Updated Window Specifications from APB

PARKFAIRFAX CONDOMINIUM UNIT OWNERS ASSOCIATION

Revised February XX, 2026

PARKFAIRFAX CONDOMINIUM UNIT OWNERS ASSOCIATION SPECIFICATIONS FOR REPLACING WINDOWS

WINDOWS 5 - 8

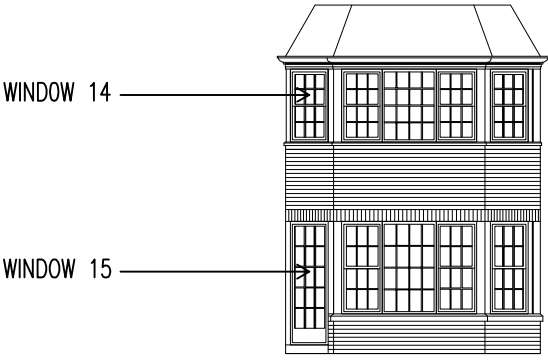
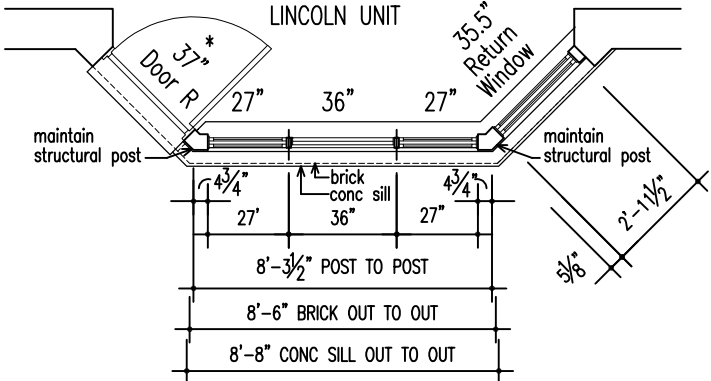
ROUGH OPENING W X H	ORIGINAL 1941 – 1943 WINDOWS	REPLACEMENT WINDOW PACKAGES					
		PACKAGE 1	PACKAGE 2	PACKAGE 3	AWNING OPTIONS		
Window Types	Steel Casement	Double Hung Single Hung	Casement	Sliding			
W.O. Window #5 3'-0" x 5'-1" Stair Window		DH16	Change from original spec F16	SL16			
			OR		OR		NOT APPLICABLE
W.O. Window #6 3'-0" x 6'-1 1/2" Stair Window		DH24	Change from original spec F24				
			OR			NOT APPLICABLE	
W.O. Window #7 3'-6 1/2" x 3'-2" Kitchen Window		SL12	C12		AWN12		
			OR		OR		
W.O. Window #8 4'-6" x 2'-1" Bathroom and Stair Top Landing		SL12	C12		AWN12		
			OR		OR
